**METROPOLITAN GOVERNMENT OF NASHVILLE AND DAVIDSON COUNTY**

Metropolitan Historic Zoning Commission  
Sunnyside in Sevier Park  
3000 Granny White Pike  
Nashville, Tennessee 37204  
Telephone: (615) 862-7970  
Fax: (615) 862-7974

**STAFF RECOMMENDATION**  
**1006, 1008, 1012 Fatherland Street**  
**February 15, 2012**

**Application:** Infill  
**District:** Lockeland Springs-East End Neighborhood Conservation Zoning Overlay  
**Council District:** 06  
**Map and Parcel Number:** 08313009400  
**Applicant:** Martin Corner, GP by Mark Sanders  
**Project Lead:** Robin Zeigler, robin.zeigler@nashville.gov

FACADE ELEVATION FATHELLAND STREET

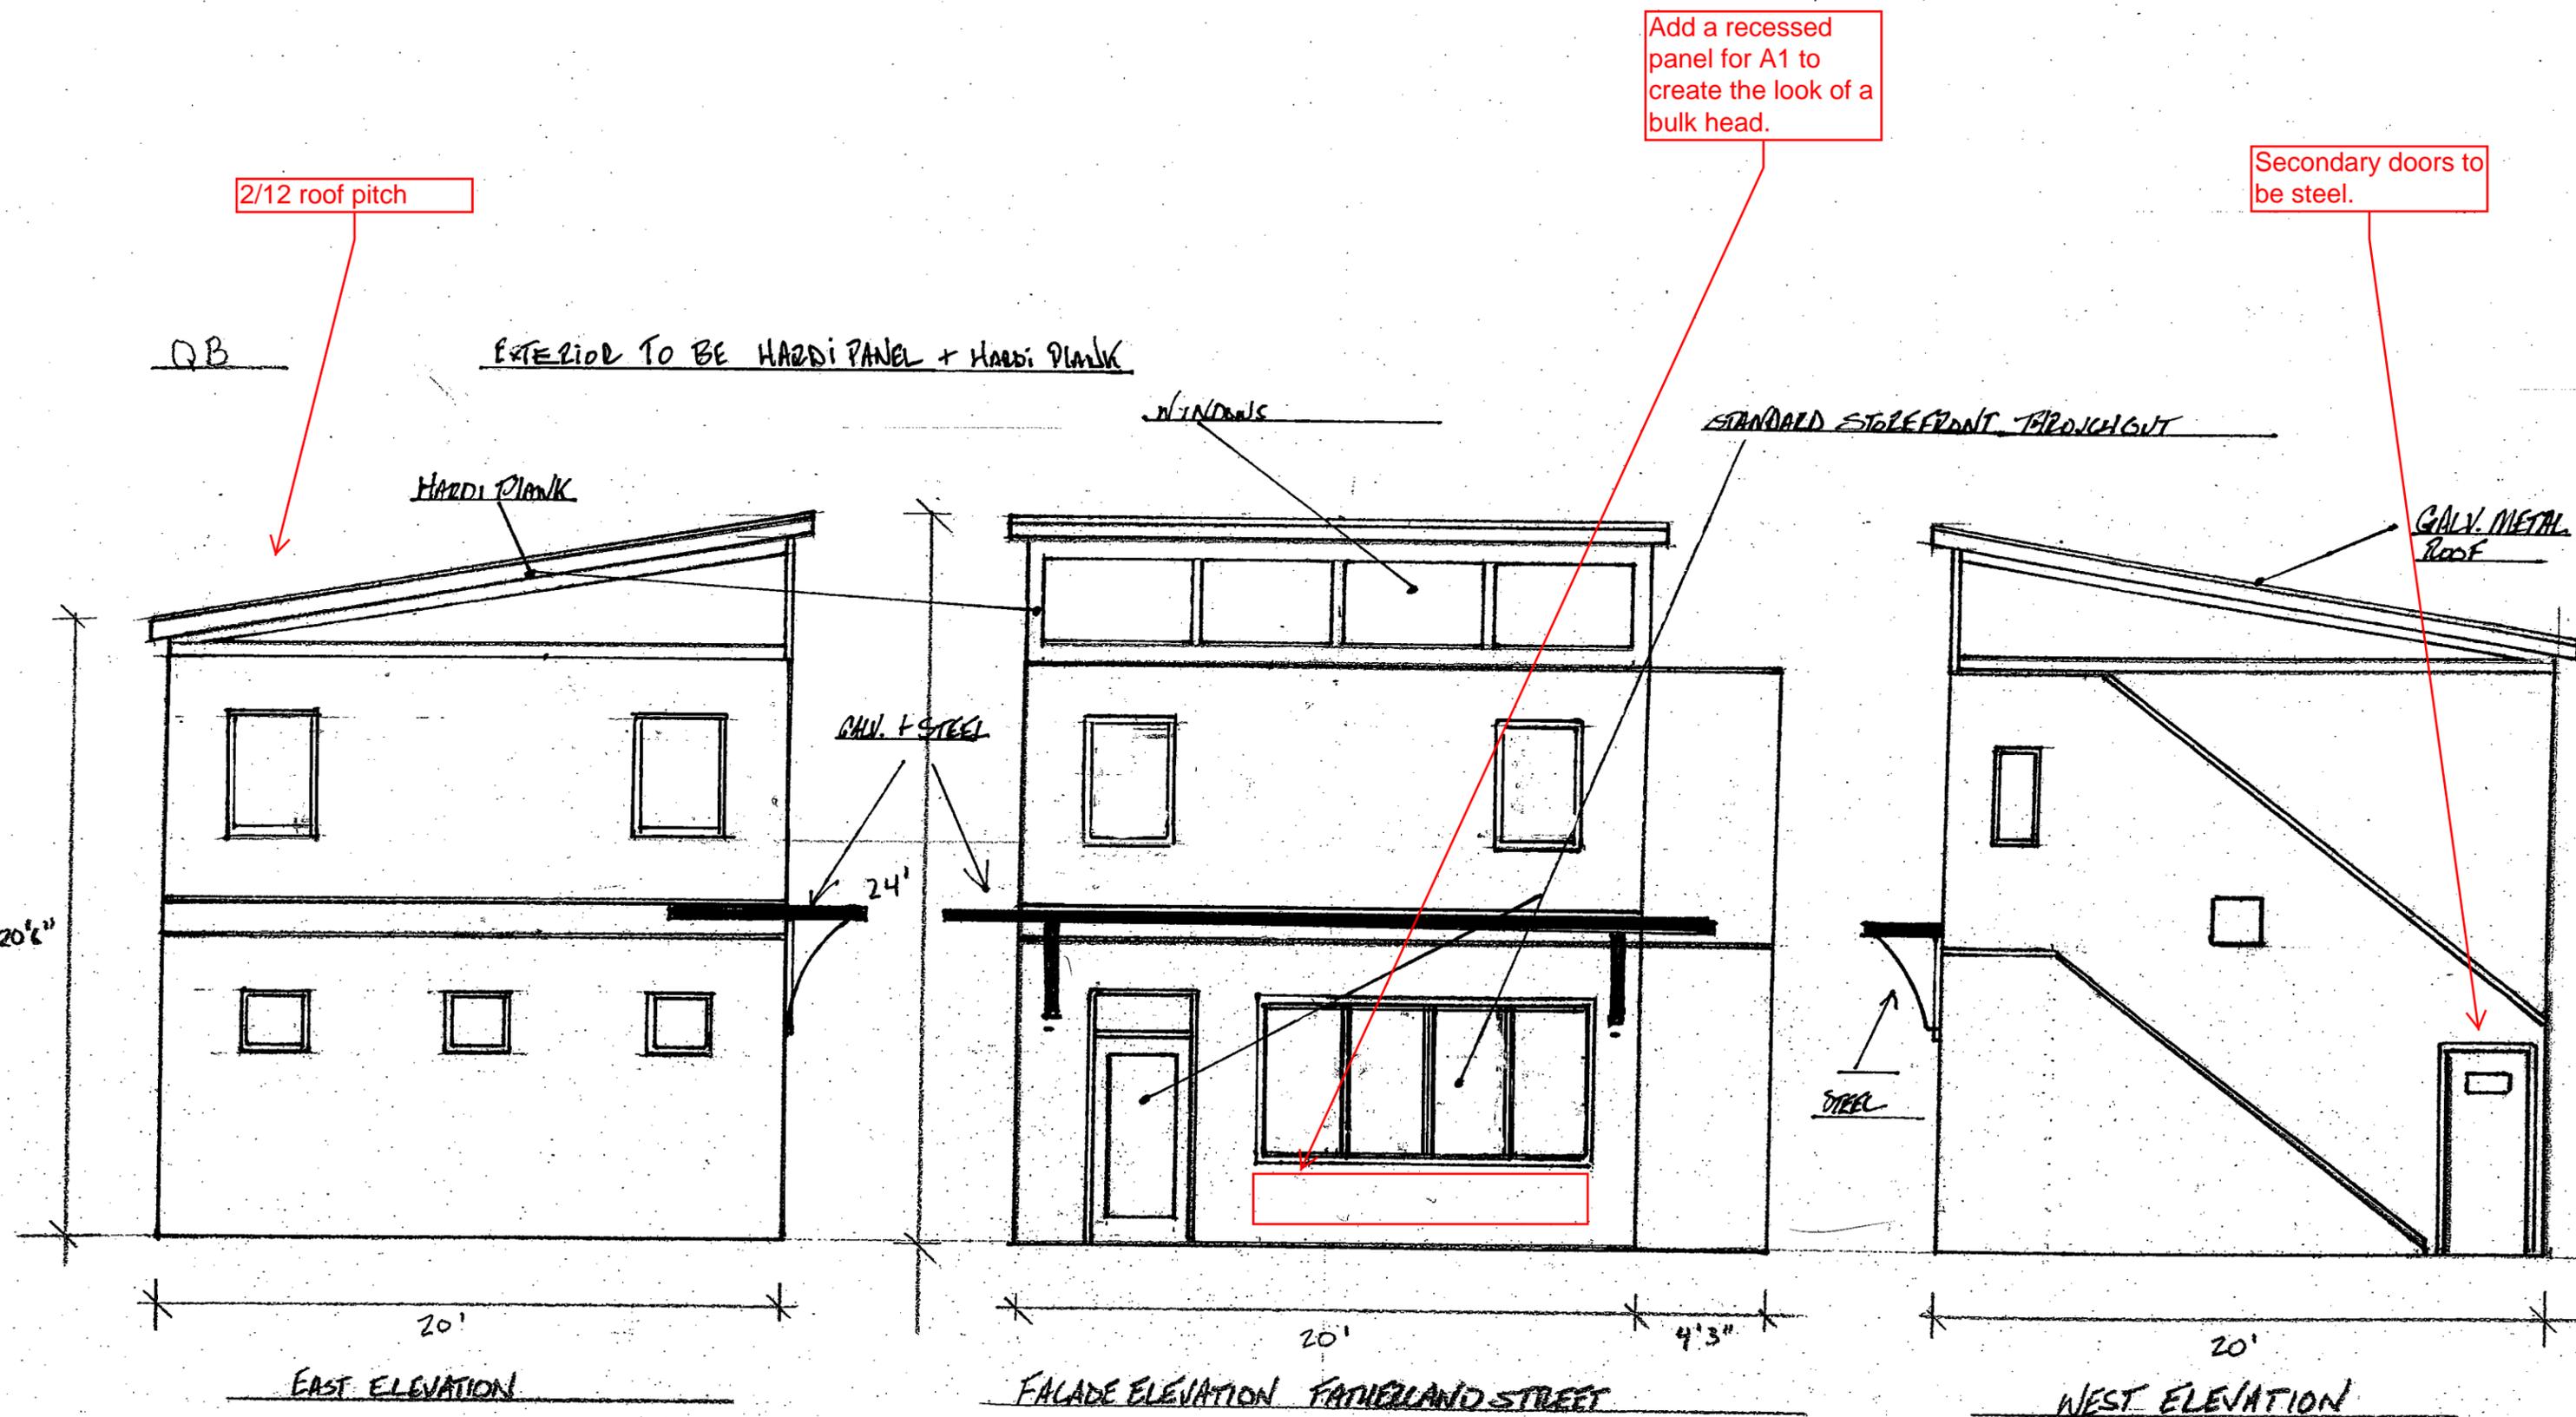
Add a recessed panel for A1 to create the look of a bulk head.

Secondary doors to be steel.
